DEPARTMENT OF NUCLEAR ENGINEERING AND ENGINEERING PHYSICS
REACTOR FACILITY

COMMENTS ON THE OCTOBER SOURCE TERM REVIEW MEETING AND ON CHAPTER V
BMI-2104

A. B. Reynolds
8 December, 1983

Zumwalt's
Plot for
Iodine.

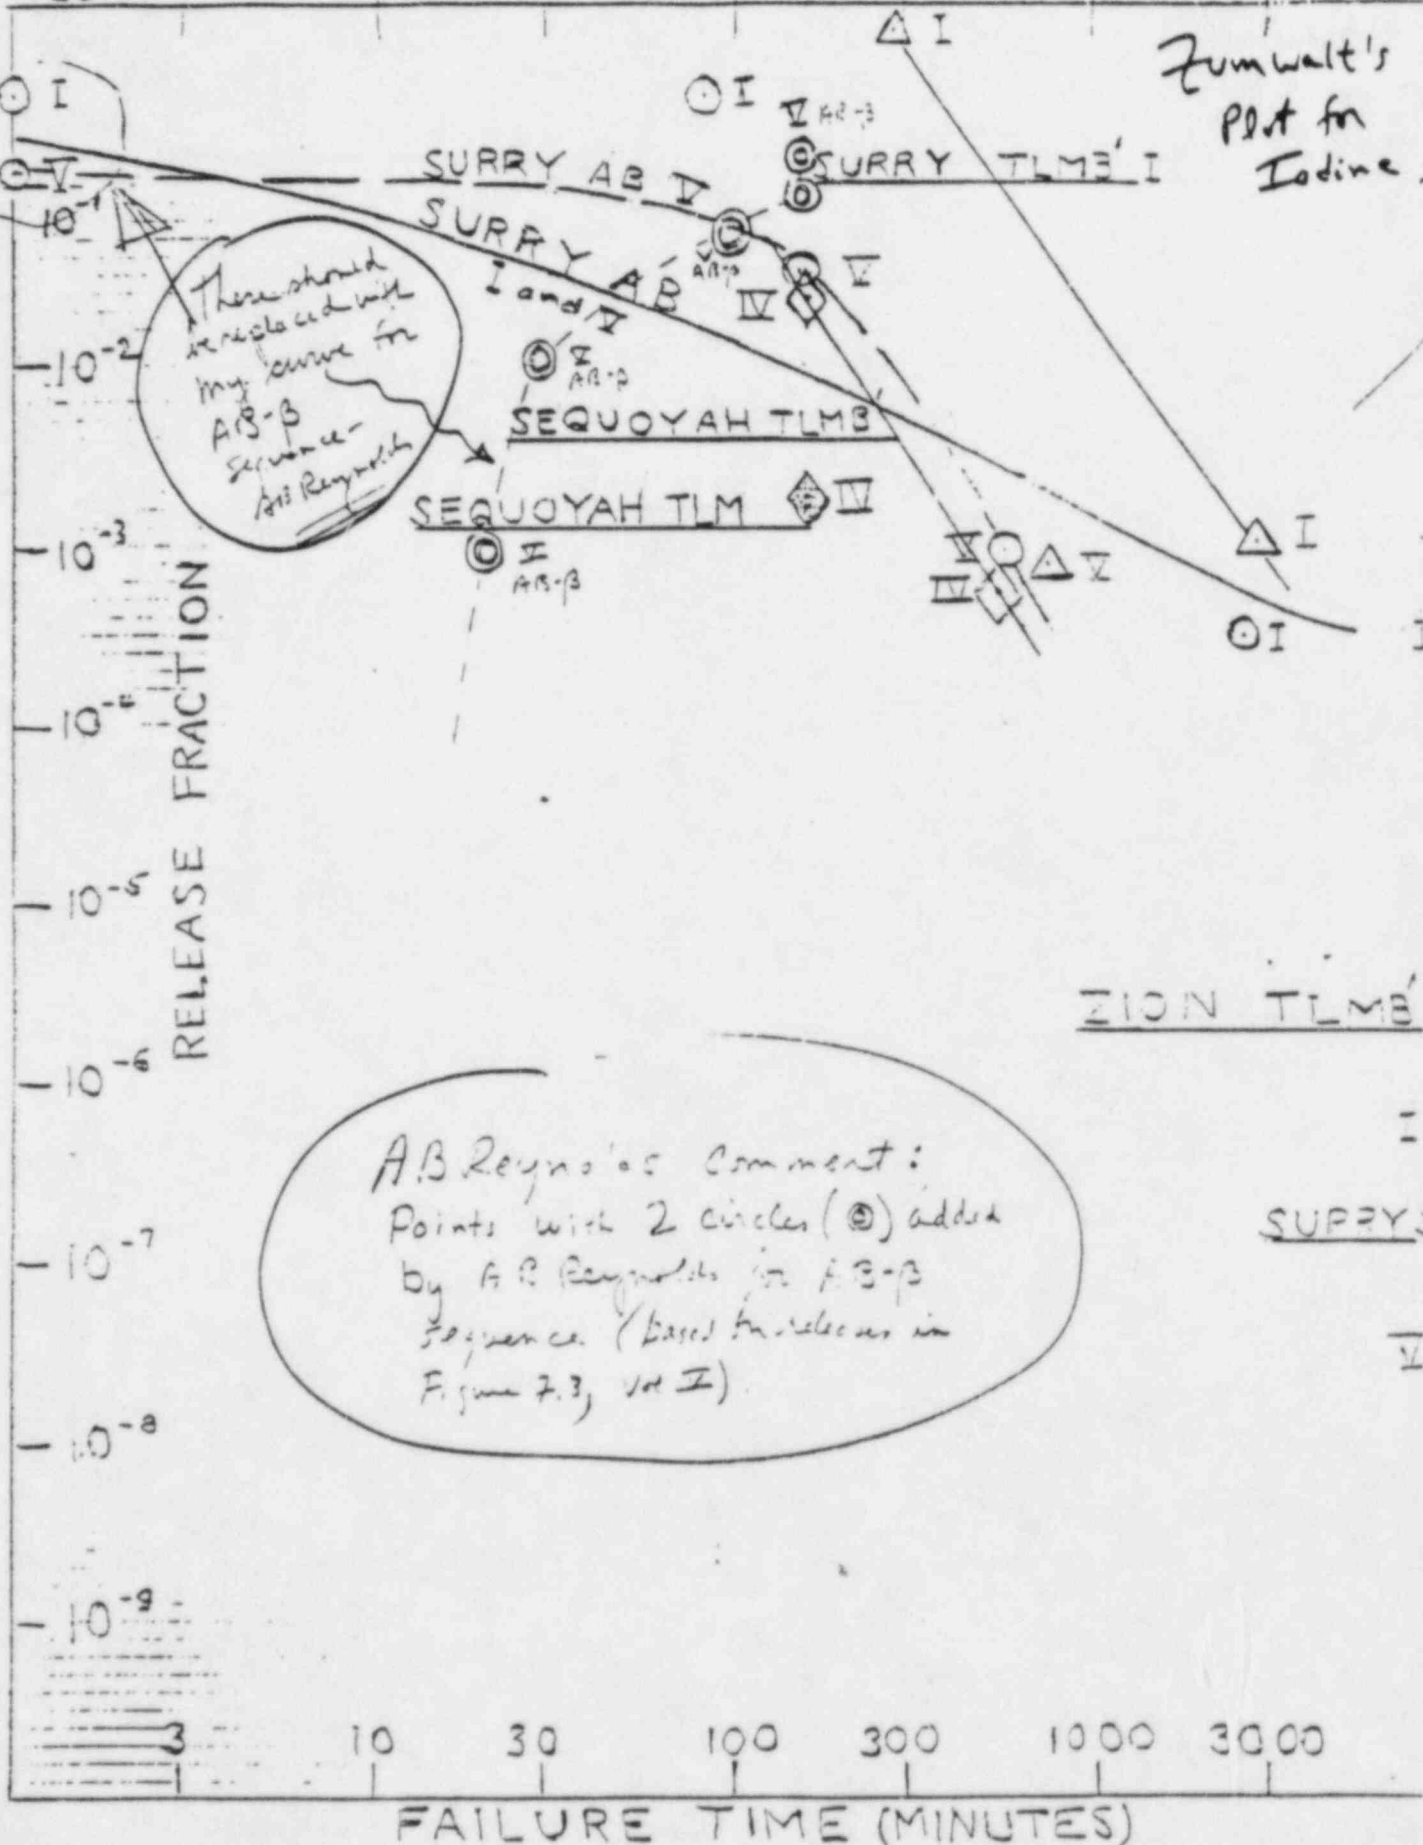
One note I might add to Zumwalt's plots. He shows the fractional releases for the AB- β as occurring at essentially zero time (since containment is bypassed). However I looked at Figure 7.3 of Volume V and noted that releases (from the auxiliary building) occur at a later time. I have plotted the results for iodine on Zumwalt's plot (see next page).

It would be useful to add the type of containment failure to Zumwalt's points, i.e. list γ , δ , ϵ , etc. beside each point.
